**CITY OF FLORENCE
PLANNING COMMISSION
RESOLUTION AR 15 05 DR 04**

A REQUEST FOR A DESIGN REVIEW TO CHANGE THE EXTERIOR APPEARANCE OF THE STILLWATER CONDOMINIUMS.

**STAFF REPORT & FINDINGS OF FACT
FLORENCE COMMUNITY DEVELOPMENT DEPARTMENT
Exhibit "A"**

Date of Report: August 6, 2015
Application: AR 15 05 DR 04

WEST ELEVATION - MAIN BUILDING

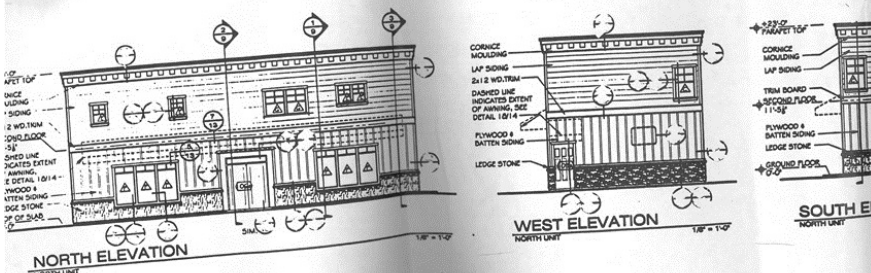
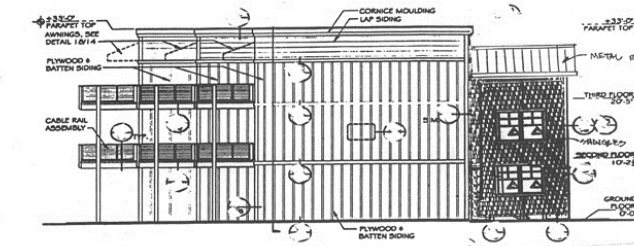
The buildings where the proposed changes will take place do not meet the current code requirements for Old Town District Area "A." The southern building is above the maximum height allowed for the district and one story greater than currently allowed. In addition, the building was not constructed with any pitched or gabled roofs and the exterior includes shapes and planes of greater than 750 square feet, specifically along the eastern and western sides with a relative offset of less than two feet.

The applicant has also proposed that the lap siding to be added to the building will be the only change. Since the trim above and below these sections on the west and east elevations of the main building are also horizontal there are no breaks in the wall plane. In addition, the applicant has provided drawings where the lap siding has been “enlarged for clarification.” It is likely that these areas of siding will be indistinguishable from the existing horizontal trim. The current trim pieces do not meet City Code with regard to 2-foot separation. The applicant shall re-orient the trim pieces (Main Building West and East Elevations - Feature 2) so that they are perpendicular in orientation to the planes they are breaking up. The applicant shall also widen the trim so that these areas meet the minimum 2-foot separation and paint them consistent with the original approval or a complementary color approved by the Planning Director of a Pacific Northwest coastal-themed, muted earth-tone palette. **(Condition 4.2)**

- 4.2. The applicant shall re-orient at least one trim piece (Main Building West and East Elevations - Feature 2) to be perpendicular to the planes they are breaking up. The applicant shall also widen the trim so that these areas meet the minimum 2-foot separation and paint them consistent with the original approval or a complementary color approved by the Planning Director of a Pacific Northwest coastal-themed, muted earth-tone palette.
